ADDENDUM | 01

Joseph's House Toilet Rooms
555 Atlantic Avenue
Camden, NJ 08105
BHA Job No. 20-004

DATE OF ISSUANCE: June 22, 2020

C-8 detail

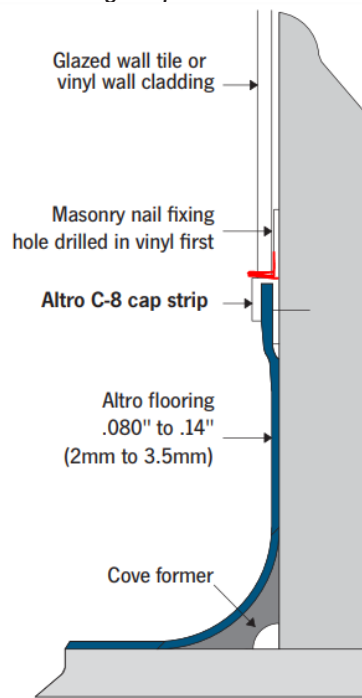
Q12. Drawing A10.1 in the Finish Legend...Floors Note #1 asks for VISEEDGE VR on top of coved ALTRO for tile to sit on. According to ALTRO, a metal cove cap is necessary. Please advise.

A12. Provide Altro C-8 cap strip at top of sheet vinyl cove and provide Schluter Jolly strip on bottom edge of porcelain wall tile. Red marks on this detail indicate location of Schluter Jolly.
